# Access Compliance Report

## Public Rights-of-Way (Curb Ramps)

Intersection ID: 50584	Main Street: GREAT_LAUREL_RD	Cross Street: GRAND_FIR_RD	Location: SE
ADA ID: A3799940B97A	Ramp Type: Perp	Initial Pass/Fail: Fail	Overall Compliance: No
Severity Score: 21.25			
Codes/Mitigation Info/Possible Solution		Field Measurements/Component Compliance

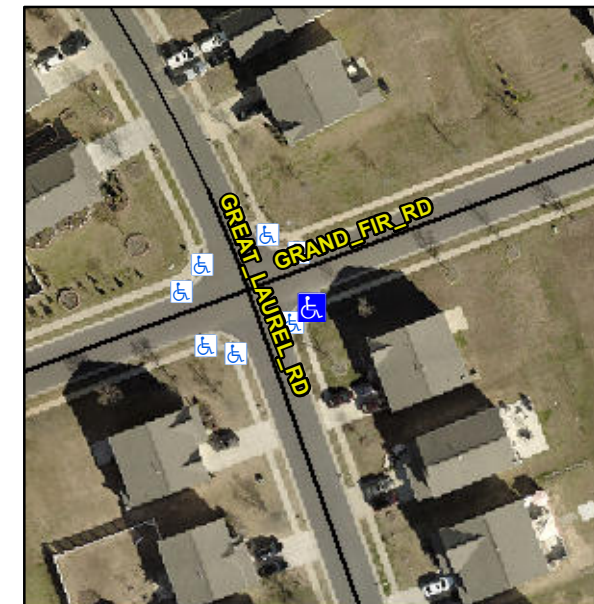
**Not Found, R304.5.1, R304.2.2**

Compliance	Description	Data	Compliance	Description	Data
N/A	Ramp Length (in)	46.5	No	Ramp Slope (%)	9.7
No	Ramp Width (in)	47.5	Yes	Ramp XSlope (%)	0.6
N/A	Flare Type LT	N/A	N/A	Flare Type RT	N/A
N/A	Flare Slope LT (%)	N/A	N/A	Flare Slope RT (%)	N/A
N/A	Flare Traversable LT?	N/A	N/A	Flare Traversable RT?	N/A
N/A	Landing Length (in)	N/A	N/A	DWS Provided?	N/A
N/A	Landing Width (in)	N/A	N/A	DWS Contrast?	N/A
N/A	Landing Slope (%)	N/A	N/A	DWS Length (in)	N/A
N/A	Landing X Slope (%)	N/A	N/A	DWS Full Width?	N/A
N/A	Landing Curb? (Y/N)	N/A	N/A	DWS Offset (in)	N/A
N/A	Shared Landing?	N/A			
N/A	Gutter Ponding?	Yes	N/A	Gutter Slope (%)	N/A
N/A	Gutter Lip Ht (in)	N/A	N/A	Gutter X Slope (%)	N/A
N/A	Painted X Walk1?	No	N/A	Painted X Walk2?	N/A
	X Walk 1 Direction	To N		X Walk 2 Direction	N/A
N/A	X Walk 1 Width (in)	N/A	N/A	X Walk 2 Width (in)	N/A
	X Walk 1 Slope (%)	2.8		X Walk 2 Slope (%)	N/A
	X Walk 1 X Slope (%)	1.1		X Walk 2 X Slope (%)	N/A

**Remove & Replace Entire Ramp.**
